Access Compliance Report

Public Rights-of-Way

(Curb Ramps)

Intersection ID: N/A	Main Street: CENTRAL_AV	Cross Street: KILBORNE_DR	Location: NW
ADA ID: 08C478C1CDC5	Ramp Type: Combination1	Initial Pass/Fail: Fail	Overall Compliance: No
Severity Score: 10			
Codes/Mitigation Info/Possible Solution		Field Measurements/Component Compliance

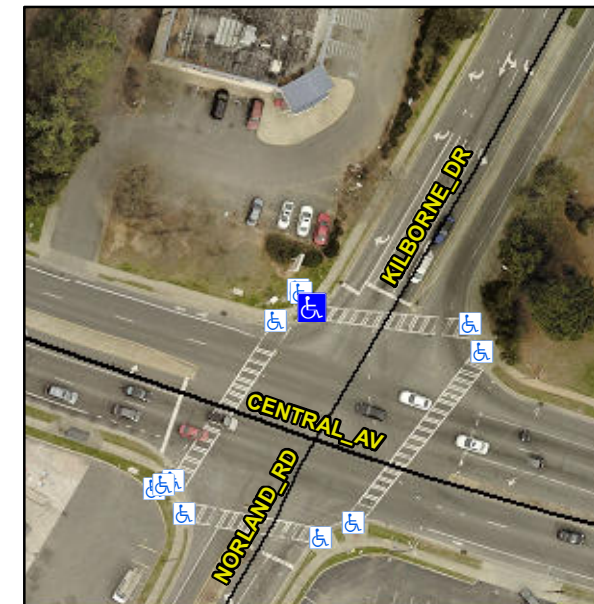
Not Found, R304.5.1, R304.5.3

Compliance	Description	Data	Compliance	Description	Data
N/A	Ramp Length LT (in)	52.0	N/A	Ramp Length RT (in)	56.0
Yes	Ramp Width LT (in)	59.5	Yes	Ramp Width RT (in)	59.5
Yes	Ramp Slope LT (%)	7.3	Yes	Ramp Slope RT (%)	6.1
No	Ramp XSlope LT (%)	2.1	Yes	Ramp XSlope RT (%)	2.0
N/A	Ramp Length (in)	24.0	Yes	Ramp Slope (%)	4.9
No	Ramp Width (in)	43.0	Yes	Ramp XSlope (%)	1.4
N/A	Flare Type LT	N/A	N/A	Flare Type RT	N/A
N/A	Flare Slope LT (%)	N/A	N/A	Flare Slope RT (%)	N/A
N/A	Flare Traversable LT?	N/A	N/A	Flare Traversable RT?	N/A
N/A	Landing Length (in)	N/A	N/A	DWS Provided?	N/A
N/A	Landing Width (in)	N/A	N/A	DWS Contrast?	N/A
N/A	Landing Slope (%)	N/A	N/A	DWS Length (in)	N/A
N/A	Landing X Slope (%)	N/A	N/A	DWS Full Width?	N/A
N/A	Landing Curb? (Y/N)	N/A	N/A	DWS Offset (in)	N/A
N/A	Shared Landing?	N/A			
N/A	Gutter Ponding?	N/A	N/A	Gutter Slope (%)	N/A
N/A	Gutter Lip Ht (in)	N/A	N/A	Gutter X Slope (%)	N/A
N/A	Painted X Walk1?	Yes	N/A	Painted X Walk2?	N/A

Remove & Replace Entire Ramp.
